## Complete Streets Committee Presentation and Minutes

# Warren Avenue Bridge Pedestrian Improvements

**Date:** November 4, 2021  
**Project:** City of Bremerton - Warren Avenue Bridge Pedestrian Improvements  
**Subject:** Complete Streets Committee (CSC) Quarterly Meeting  
**Attendees:**

# Alternative 3 – 12' Shared Use Path, West Side

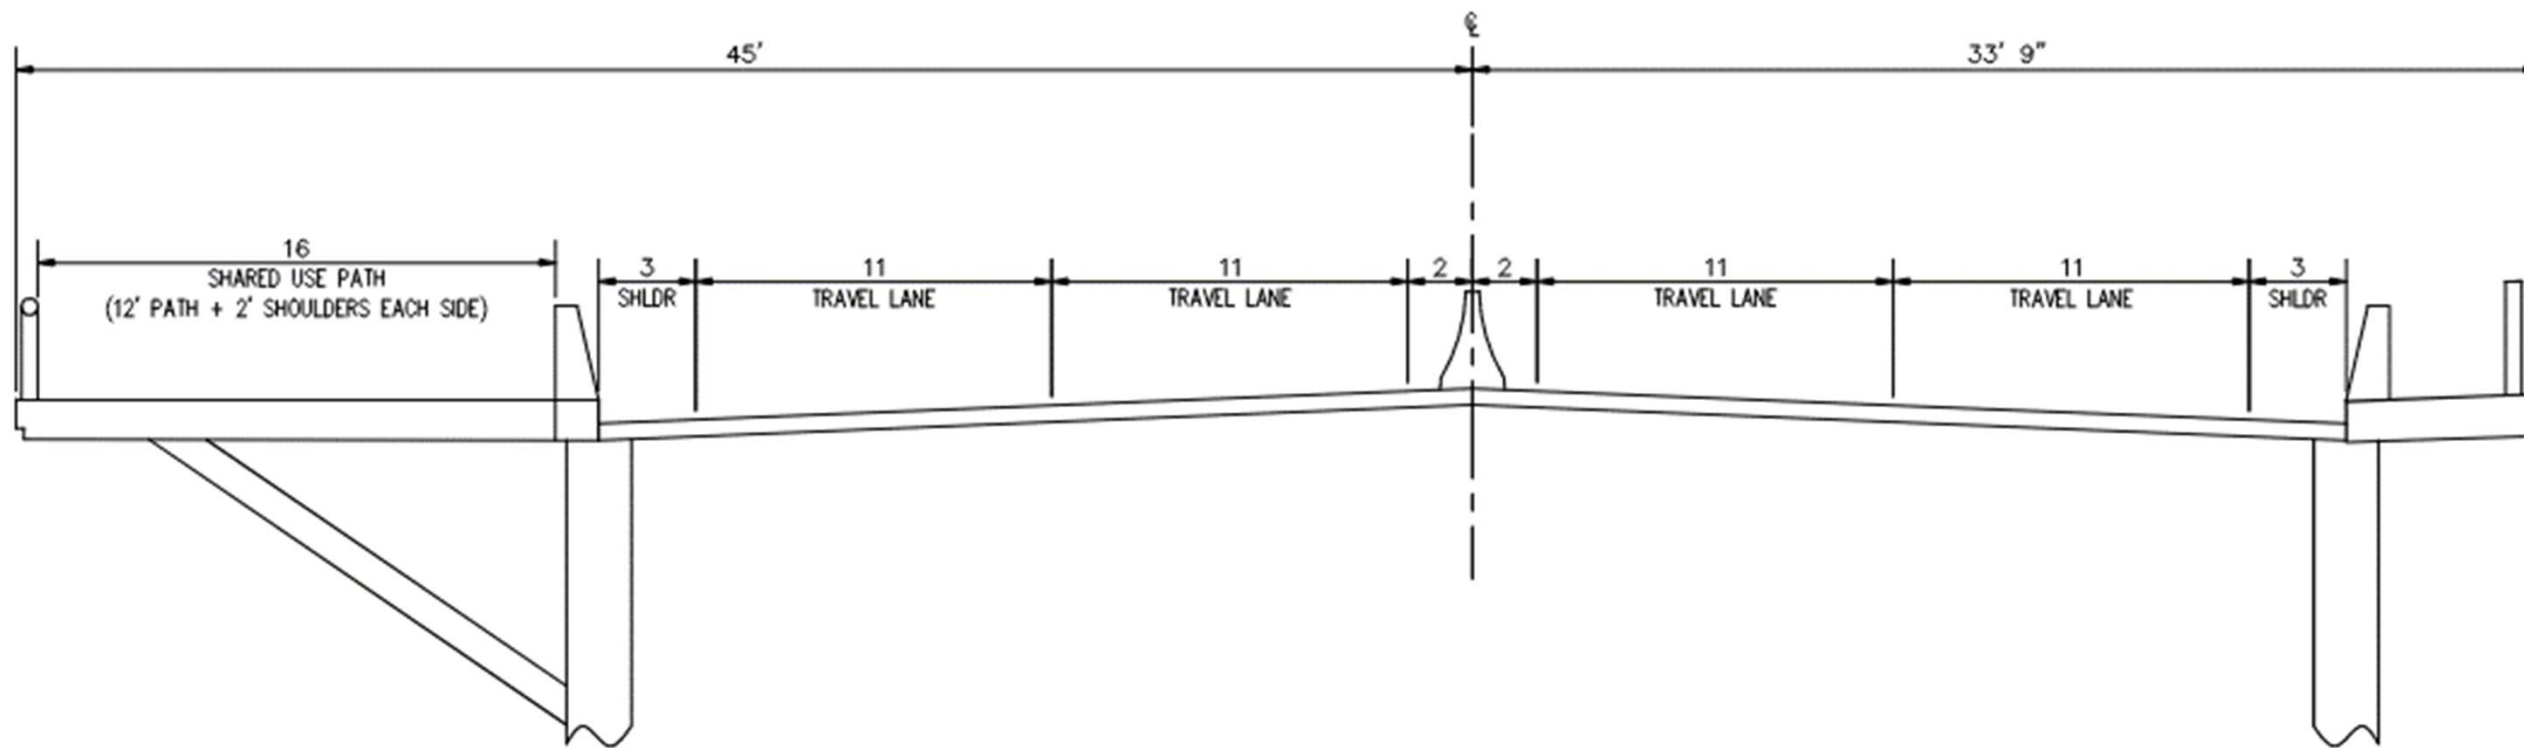
- Discussion about if the presented alternatives are the proper alternatives. 16' path options should be combined into an A/B option 4
- Replace Option 3 with a 12' facility on each side

# Alternative 4 – 12' Shared Use Path, East Side

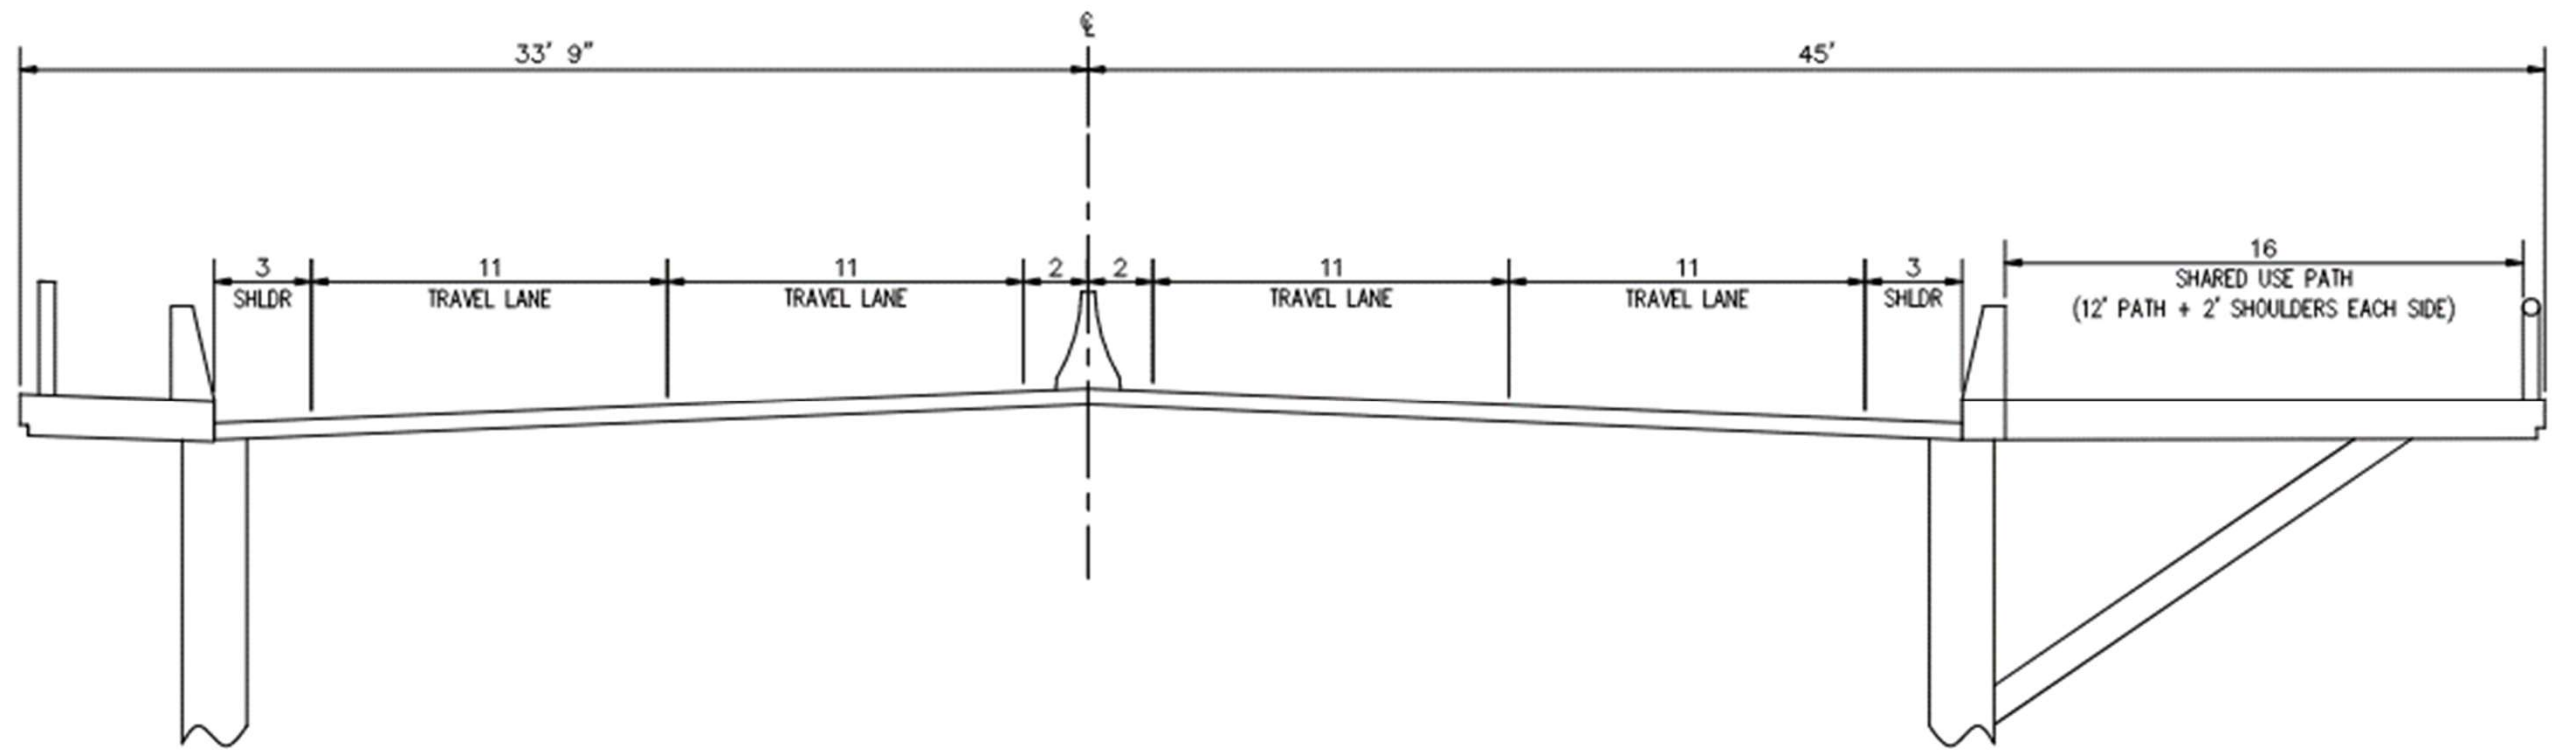
- What is the lifespan of the bridge and how long does this project extend the life?
- Connectivity to adjacent sections of Warren should be considered
- There are a lot of people walking on the bridge at nighttime
- East side of the bridge is where most volume is.
- Alternate 4 needs connectivity to Olympic College
- Prefers both 3 & 4, separate shared use paths.
- Would like to know if the alternatives accommodate bike usage for 30 years (remaining life)
